WURLITZER SERVICE SLANTS

SUBJECT: Installation Instructions for Wurlitzer Model 3500 Series Phonographs.

TOP TUNES - GOLD AND BURGUNDY PROGRAMS

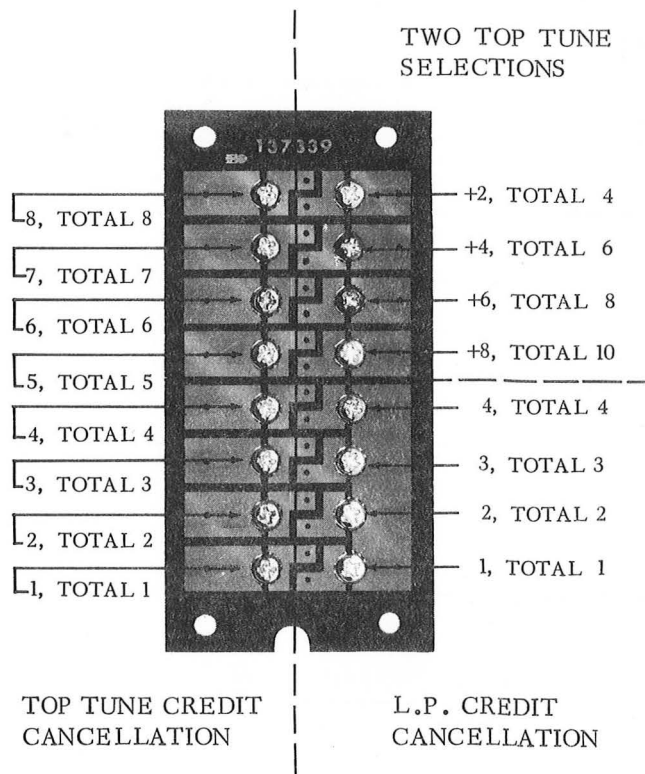
COMPLAINT: Top Tune and L.P. Credit Cancellation adjustments do not operate as stated in instructions.

CORRECTION: To correct the above complaint, substitute the following instructions for Top Tunes - Gold and Burgundy Programs and L.P. Credit Cancellation:

Establishing a 50¢ credit lights the Gold Program and Burgundy Program Buttons. Pressing a button electrically selects 2, 4, 6, 8, or 10 predetermined selections. The number of selections, as well as the number of credits cancelled, is determined by the placement of bridging screws on the Cancel and Top Tune Option Board located on the Junction Box.

Two Top Tunes will be selected if all the Top Tunes Selection bridging screws are backed out. Tightening the +2 screw increases the total to 4 Top Tunes. Tightening the +2 and +4 screws increases the total to 6 Top Tunes. Tightening the +2, +4, and +6 screws increases the total to 8 Top Tunes etc.

The total number of credits to be cancelled must equal the number of credits established for 50¢.

No credit will be cancelled if all the Top Tune credit cancellation bridging screws are backed out. Tightening the number 1 bridging screw increases the total credits cancelled to 1. Tightening the number 1 and 2 bridging screws increases the total credits cancelled to 2. Tightening the number 1, 2, and 3 bridging screws increases the total credits cancelled to 3; etc.

Unused bridging screws should be backed out sufficiently to prevent any possible electrical connection between patches.
